ModeS-WP01-06

RTCA Special Committee 209

Mode S Transponder MOPS Development/Maintenance

Proposed Changes to Comm-B Requirements Section §2.2.19.2.3.3 in the working draft of DO-181D

Figure 2-19 Comm-B Closeout

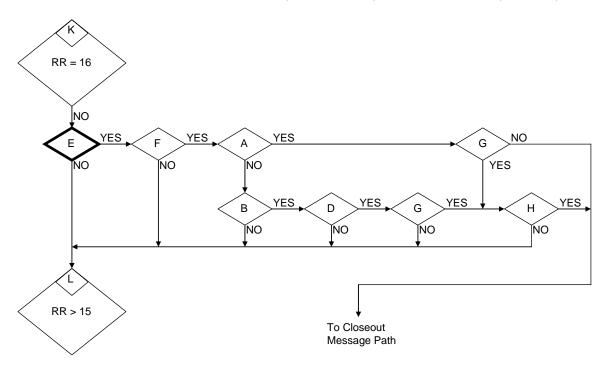
The requirements for non-multisite Comm-B closeout protocol are contained in the MOPS section \$2.2.19.1.12.4 and in the SARPs section \$3.1.2.6.11.3.3.2. In both of these documents the Comm-B closeout is achieved by the reception of an interrogation containing PC=4. This is precluded by the conditions that the multisite timer is not running and the message has been extracted at least one time. However, according to

Figure 2-19, an interrogation with PC=4 will not successfully closeout a message unless the RR field in the same interrogation is equal to 16. This appears to be an error in the flowchart. The following figure offers a suggested correction to the section of flowchart on the center left between the decision K (RR = 16, NO) and the test for L (RR > 15):

Multisite Comm-B reservation with IIS=0 is not to be accepted by the transponder (DO-181D, §2.2.19.2.3.1). However, the Comm-B reservation path in the flow chart (Figure 2-19) currently shows no means to reject such a request. This could be rectified by adding to the series of notes below the figure as shown below:

<u>10. THE B-TIMER IS STARTED ONLY IF IIS≠0</u>
